**HUGHES
SERVICE INFORMATION
NOTICE**

NOTICE NO. HN-137

SUBJECT: REPLACEMENT OF RADIO TRANSMIT/INTERCOM TRIGGER SWITCH;
REWORK OF CYCLIC PITCH STICK GRIP ASSEMBLY*

MODELS AFFECTED: All 500 Model 369H Series Helicopters

Figure 1. Rework of cyclic pitch stick grip assembly

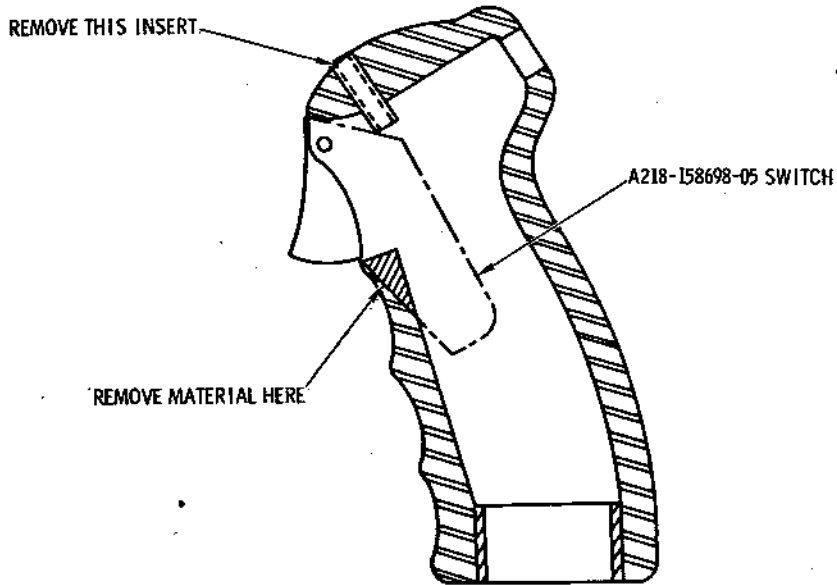
i. Rework cyclic grip as follows (see Figure 1):

1. Press or pull insert from top of grip.
2. Make template of profile of new A218-158698-05 trigger switch.
3. Using file, blade or equivalent routing tool, remove material from lower inside edge of hole for trigger switch to permit installation of new switch. Use template to determine amount and location of material to be removed.
